RE: Herald Harbor ~ Hall & Mahogany Roads
341 Hall Road
Crownsville, MD 21032
Variance Application

Pre-file comments were received from the Office of Planning & Zoning in a memo dated May 14, 2025. A point-by-point response to those comments (*in italics*) is provided below:

CONFIRMATION OF PRE-FILE (2025-0039-P)

SCALE: 1"=20'			
													DATE: JULY 15, 2025			
												PROJ. NO: HD14523				
												SHEET 1 OF 1

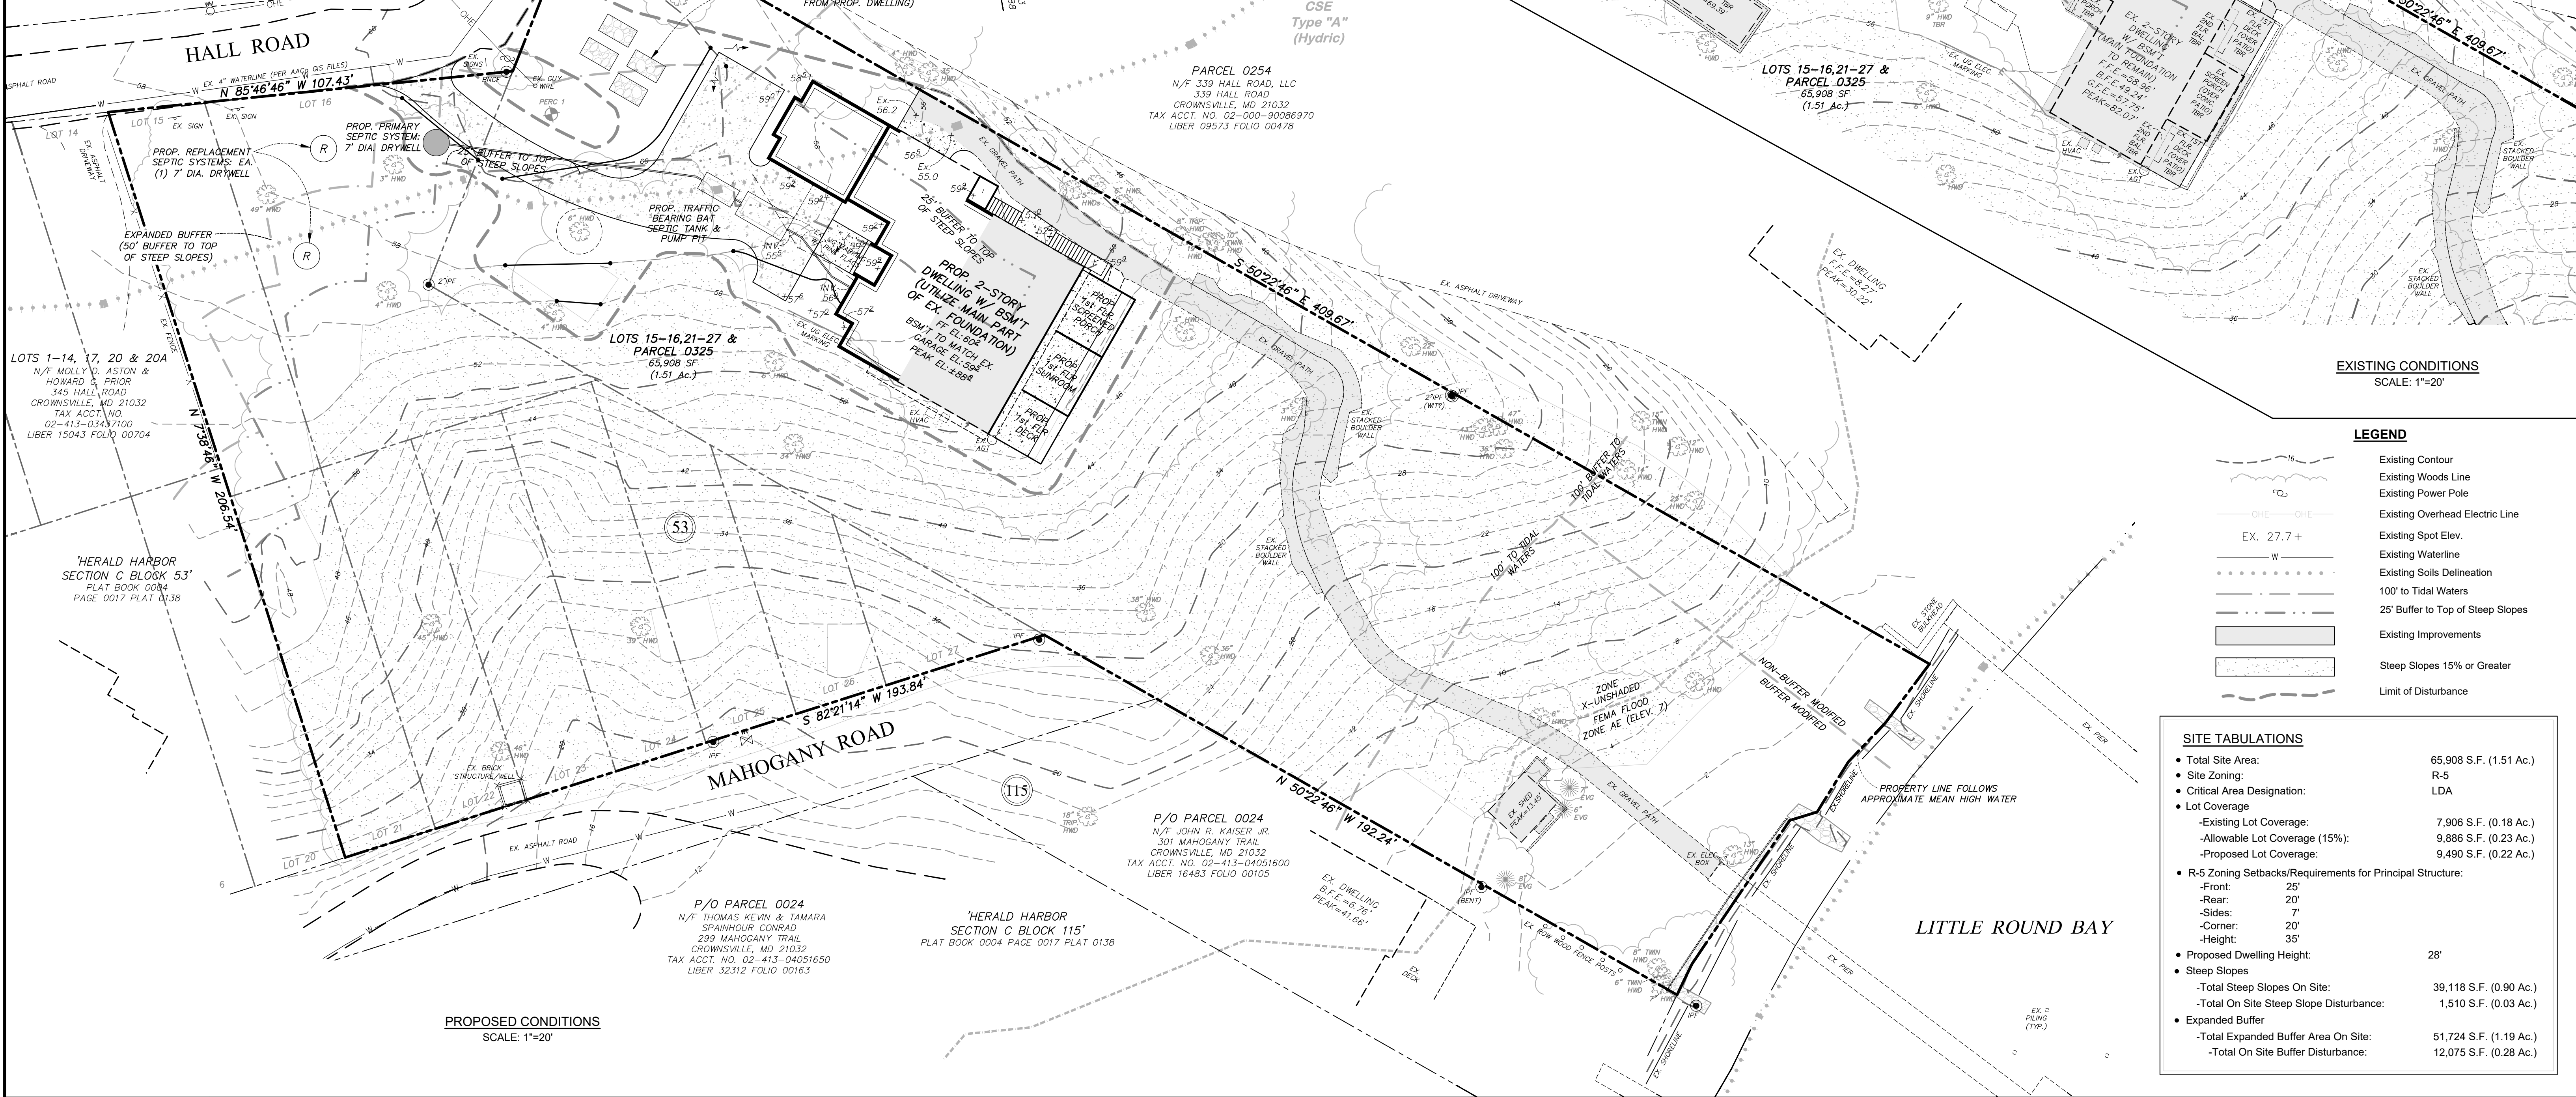
The site plan will need to label the proposed height of the dwelling in addition to the existing label for the number of stories.

1. Provide separate sheets for existing and proposed conditions on the property. The existing conditions plan sheet should state what structures are to be removed and what are to remain.

2. Label what is to happen to the existing inlet located at the proposed 2-story addition and garage. In addition, note where the inlet’s outlet is located.

4. The proposed primary septic system drywell and the two proposed replacement septic drywells are located on the western adjacent property. A portion of the driveway is also

located on the western adjacent parcel. An easement will need to be obtained prior to Grading Permit and Building Permit approvals, as they appear to be off-site.

8. SWM drywells are to be downgradient of buildings. The location of the proposed SWM drywells is to be relocated. It should be noted that the installation of SWM drywells on slopes greater than 20% should be avoided.

- *The proposed computed height is now included on the site plan.*

- *The site plan has been updated to show both an existing conditions and proposed layout. The existing conditions plan shows the structures to be removed.*

- *This inlet will be demolished before the proposed garage is built. The location of the outlet is not relevant as it will be demolished.*

- *The septic drywells are located within the subject property, please refer to the Lot Consolidation Deed included with this submittal.*
5. Label Hall Road and Mahogany Road as private or public. Provide their functionality class and their widths.

- *There is no feasible location for SWM practices downgradient of the proposed dwelling. All areas downgradient are within the steep slopes and/or located in an area mapped with hydric soils. The proposed location is the only feasible location for stormwater management. Positive drainage from the dwelling roof leaders to the drywells will be demonstrated at grading permit.*
